State of New M		Form C-103
• Office District I = (575) 393-6161	Energy, Minerals and Nat	tural Resources	Revised July 18, 2013
1625 N. French Dr., Hobbs, NM 88240			WELL API NO.
<u>District II</u> + (575) 748-1283 811 S. First St., Artesia, NM 88210	OIL CONSERVATION	N DIVISION	30-025-28255
District III = (505) 334-6178	1220 South St. Fra		5. Indicate Type of Lease
1000 Rio Brazos Rd., Aztec, NM 87410			STATE FEE X
<u>District IV</u> = (505) 476-3460	Santa Fe, NM 8	37303	6. State Oil & Gas Lease No.
1220 S. St. Francis Dr., Santa Fe. NM 87505			
	TICES AND REPORTS ON WELL	S	7. Lease Name or Unit Agreement Name
	OSALS TO DRILL OR TO DEEPEN OR P		
	ICATION FOR PERMIT" (FORM C-101) I	FOR SUCH	Felton / .
PROPOSALS.)	Gas Well Other	OBBS OCD /	8. Well Number 3

OXY USA WTP LP - Proposed Felton A #3 API No. 30-025-28255

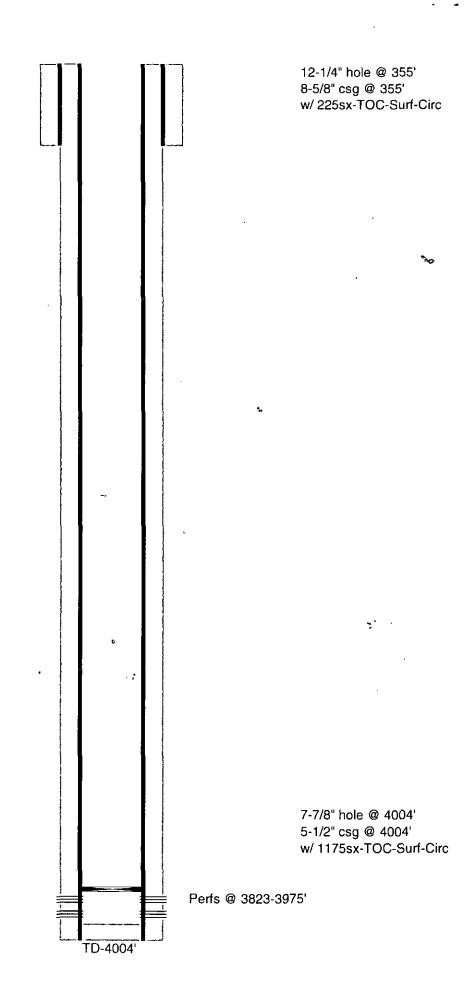
25sx @ 1850-1675' WOC-Tag |535'-|3L0'
